SERVICE BULLETIN No.1126

COACH MODEL	: C2045
BULLETIN TYPE	: Safety Recall Program – NHTSA Campaign number 04V-422
MANUAL & SECTION	: N/A
PARTS BOOK REVISION	: No
DATE	: December 3, 2004
SUBJECT	: Main junction box – top cover
TERMS & CONDITIONS	: Refer to the Warranty Information in this Bulletin.

Figure 1: C2045 main junction box

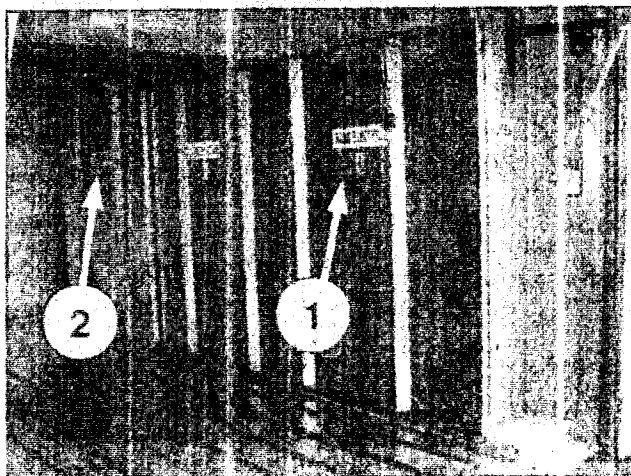
On the above-mentioned coaches, it is necessary to add a closing panel to the top of the left hand and right hand sections of the main junction box in order to prevent possible damage to electrical components.

- 1) Open the main junction box door giving access to the "Basic Electrics" compartment (see 1, Figure 1).
